## SERVICE INFORMATION No. SI 40-147

Lycoming Service Bulletin No. 615 Diaphragm-Type Fuel Pump Replacement

Service Bulletin No. 615  
Engineering Aspects are  
FAA Approved

SUBJECT: Diaphragm-Type Fuel Pump Replacement

**Figure 1**

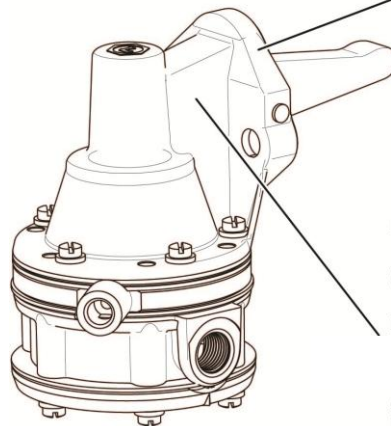
1. Identify and remove any fuel pump part number 62B26931, with a date code identified in Table 1 (Figure 1), from all Lycoming engine models identified above and from your inventory of spare parts.

Figure 1 identifies the location of the manufacturer's code on the fuel pump. The manufacturer's code can be on either the left or right side of the flange or web.

If manufacturer's Code is located on the flange, the fuel pump is not affected by SB 615.

2. Return all affected fuel pumps to Lycoming Engines, and procure a new fuel pump using the proper warranty procedure listed below.
3. Replacement fuel pumps will be the same part number (62B26931). Affected date codes will show compliance with this Service Bulletin with a “SB 615” stamped under the date code (Figure 2). Unaffected date codes will not have a “SB 615” stamp.
4. Install the new fuel pump with a new gasket in accordance with the Lycoming Direct Drive Overhaul Manual.
5. Record the serial number of all of the fuel pumps returned and all of the replacement fuel pumps received and which engine they are installed on in compliance with this Service Bulletin in your engine logbook.
